DIST	COUNTY	ROUTE	KILOMETER POST TOTAL PROJECT	SHEET No	TOTAL SHEETS
04	SF	80	13.2/13.9	45R2	1204

CONTRACT CHANGE ORDER NO. \_\_\_\_\_  
 SHEET \_\_\_\_\_ OF \_\_\_\_\_

# MAIN SPAN STRUCTURE PIPING PLAN

## M-9

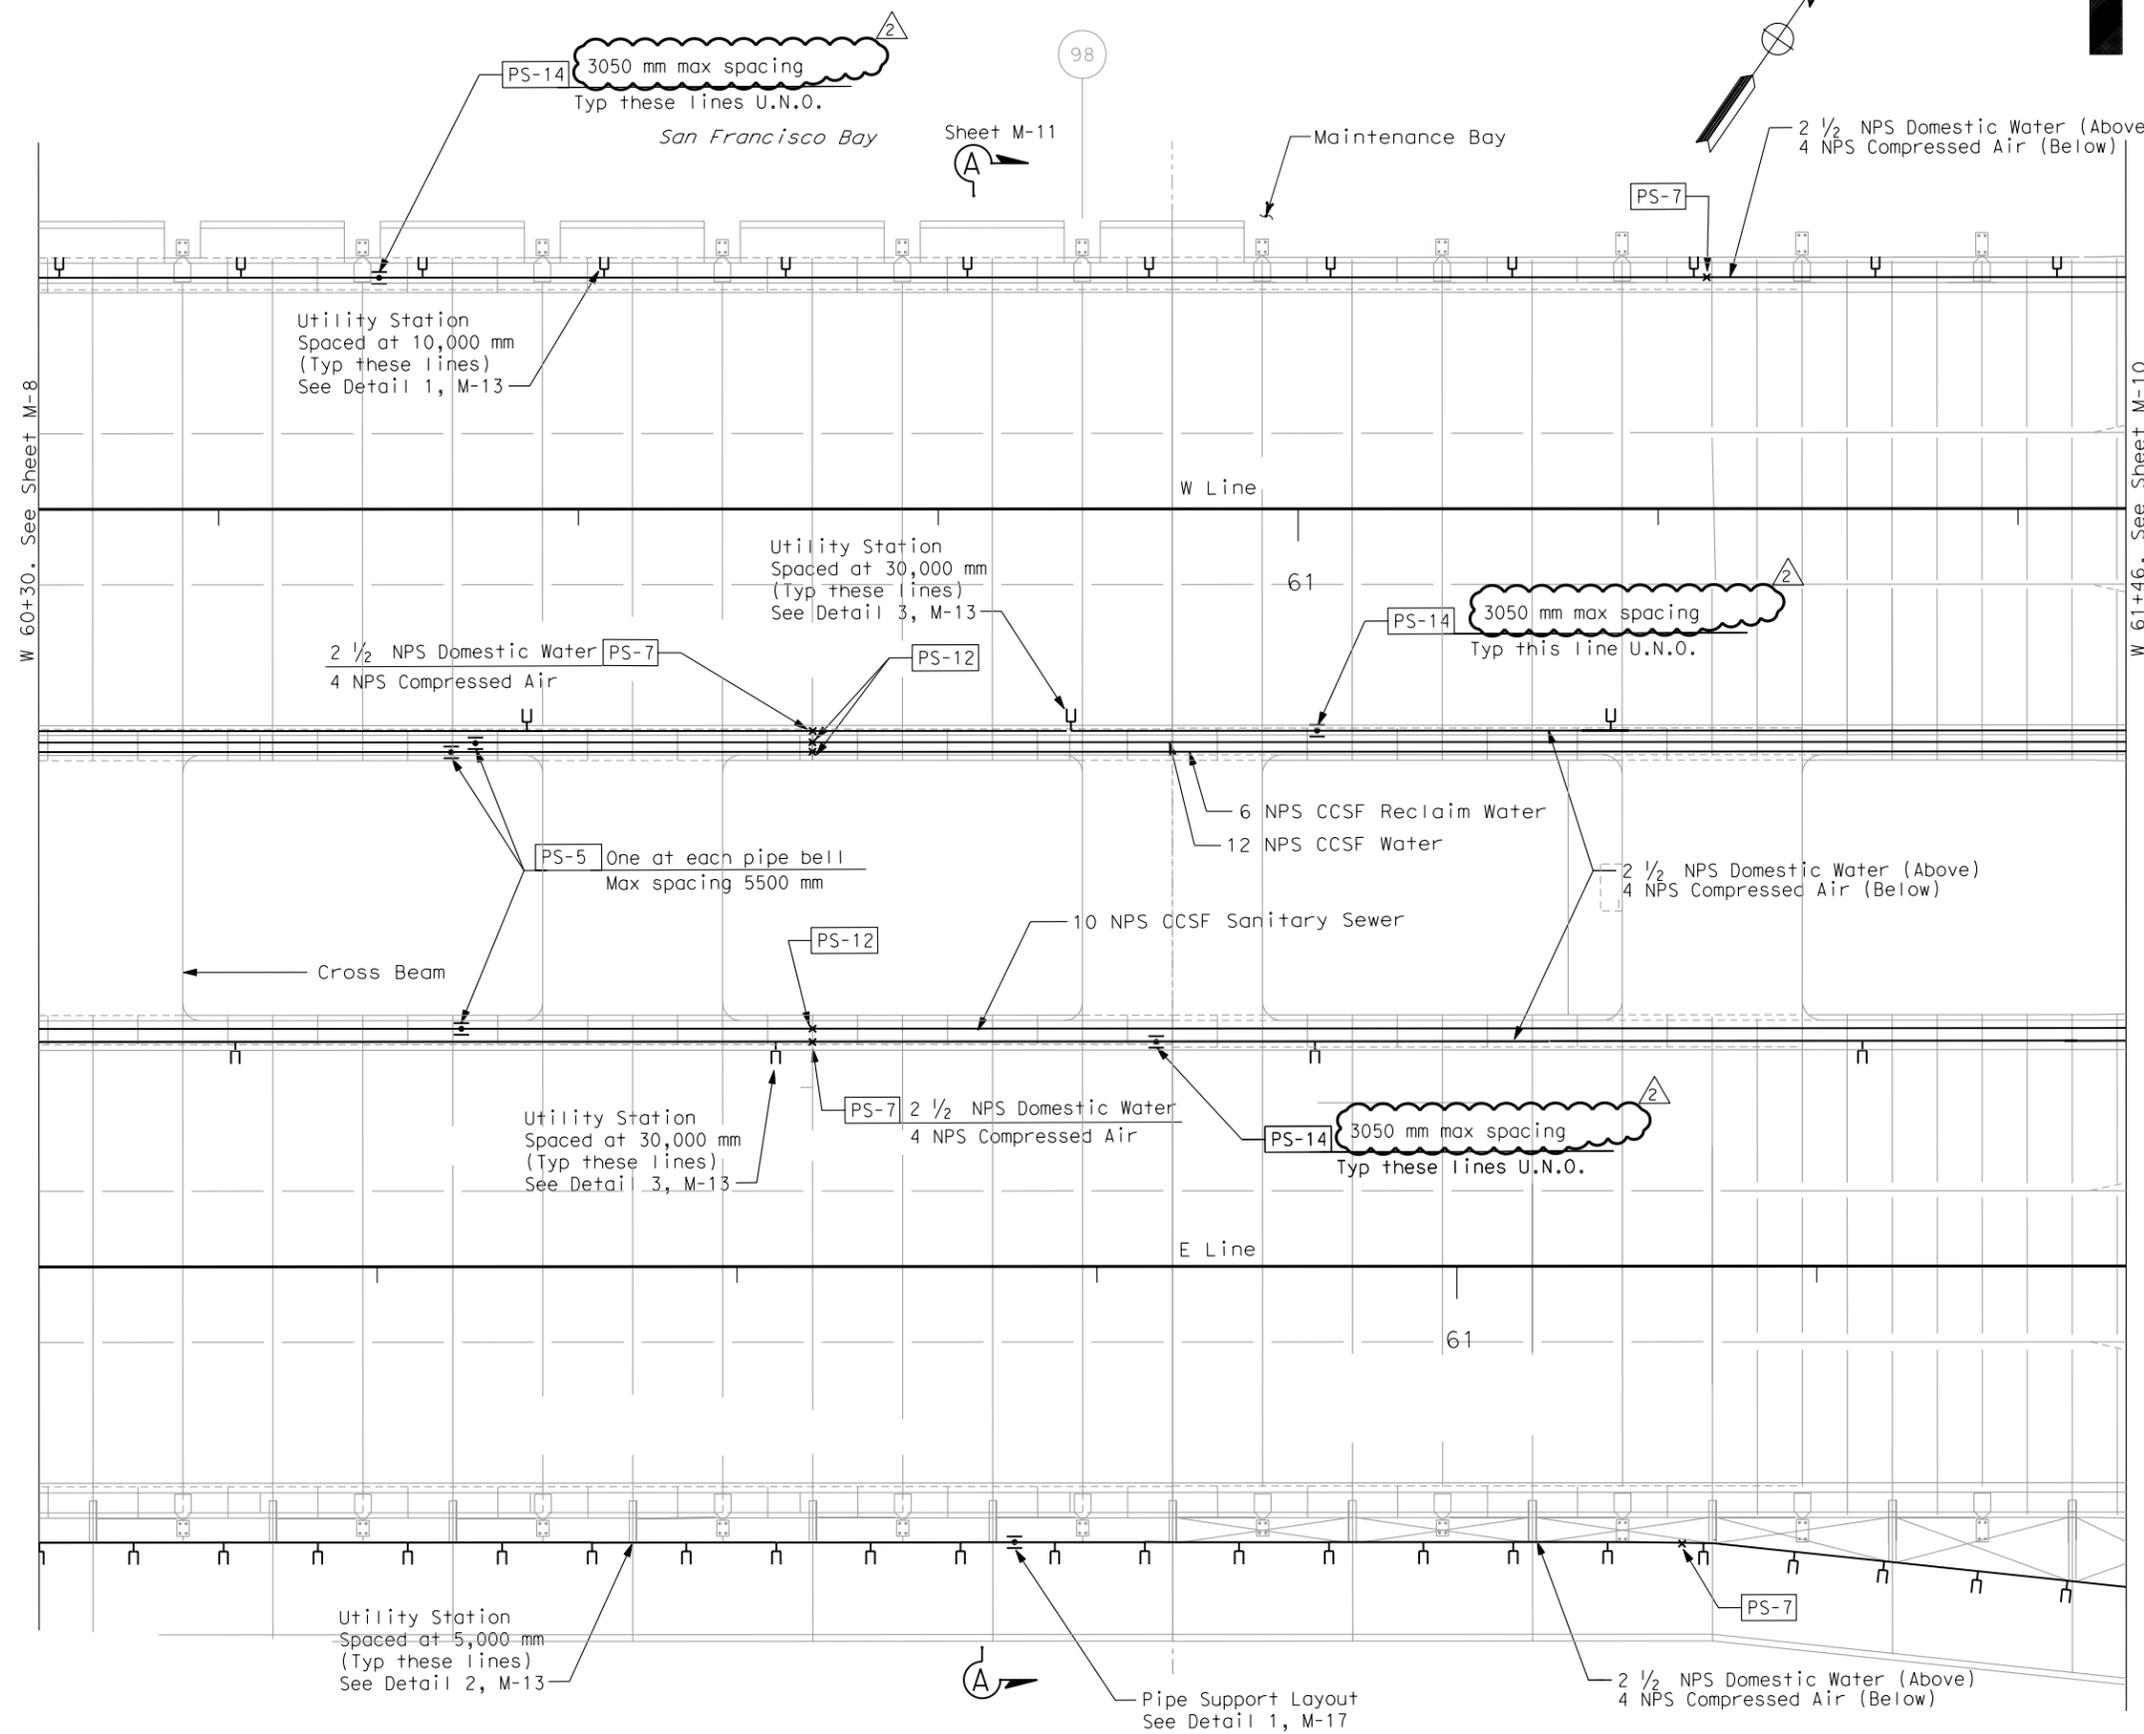
REQUEST FOR INFORMATION NOT ADDRESSED IN THIS CCO REMAIN IN FORCE					
MARK	DATE	DESCRIPTIONS	BY	CH'D	CCO#
$\triangle$ 2	1/18/08	MECHANICAL MODIFICATIONS	VY	BM	31
$\triangle$ 1	9/05/07	MECHANICAL MODIFICATIONS	BM	RM	31
REVISIONS
